COMMUNITY COLLEGE OF ALLEGHENY COUNTY  
PURCHASING DEPARTMENT  
800 ALLEGHENY AVENUE, PITTSBURGH, PA 15233

**ADDENDUM NO. 1**  
**BID PROPOSAL NO. 1039**  
**UPGRADE LANDSCAPING AT ALLEGHENY CAMPUS**  
**DECEMBER 14, 2018**

PLAN: STEPPING STONES (TYP)

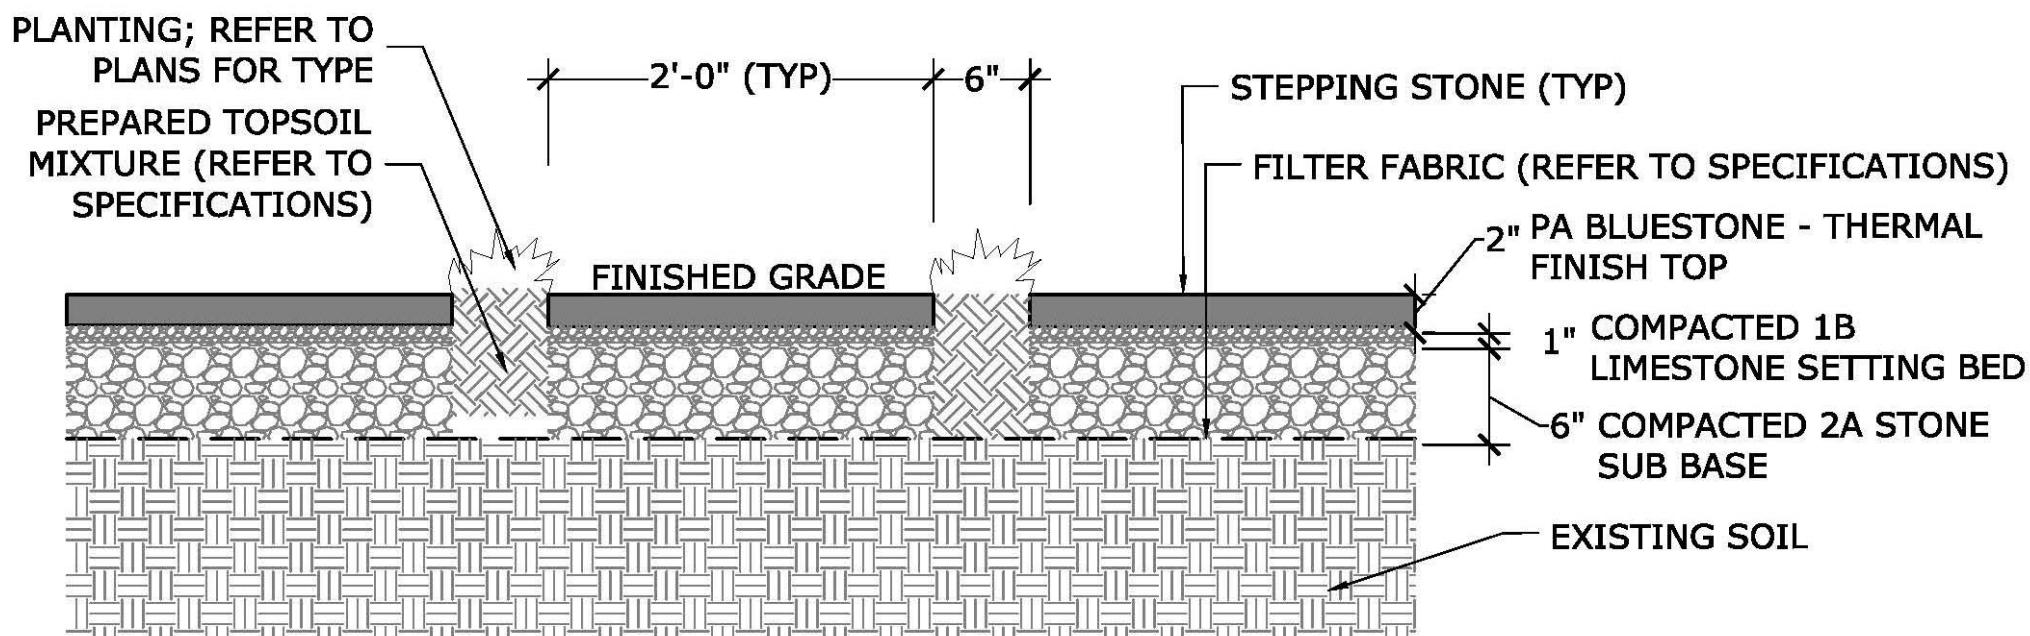
2. The stepping stones specified are only 7/8" thick. Please clarify material/dimensions.  
*See sketch SK1.1*

1. Stepping stones shall be rectangular cut PA Bluestone with the approximate dimensions of 24" x 36" x 2" minimum thickness. Set each stone plumb and level and install on aggregate setting bed. Minimal sand may be used as needed to level stone on base.
2. Thermal finish top
3. Submit samples for approval prior to installation.

Limestone Belgian Block Example

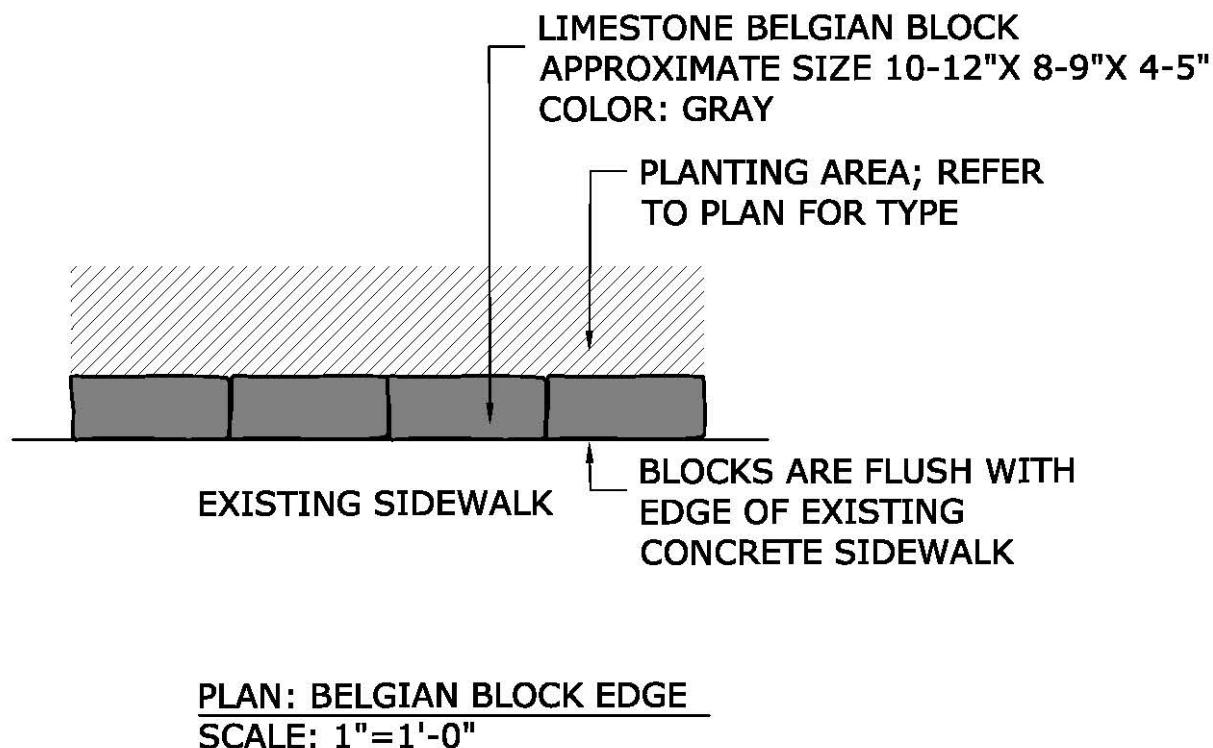
6. Please clarify the type of granite Belgian block for the edging. Do you have a source?

Can we use standard Belgium block cobblestones used for paving older city streets?

These are commonly limestone cobblestone Belgium Block. If you are specifying granite these are much more expensive and a different type of material. Please clarify type of Belgian Block.

Can you provide photo?

*Refer to SK1.2 and Sk1.3. The Belgian block cobblestones are limestone. For source information*

*refer also to the attached Section 32 14 40 – Stone Paving.*

1. ~~Gray granite Limestone~~ Belgian block approximate size 10"-12" x 8"-9" x 4"-5", Color "Salt & Pepper" Gray
2. Submit samples for approval prior to installation.
3. Source: Dragun's Landscape Supply 2480 Rochester Road, Franklin Park, PA 15143. Phone 412-635-8441. Or contractor to submit alternate source for materials (and provide samples from this supplier) for Landscape Architect's approval.
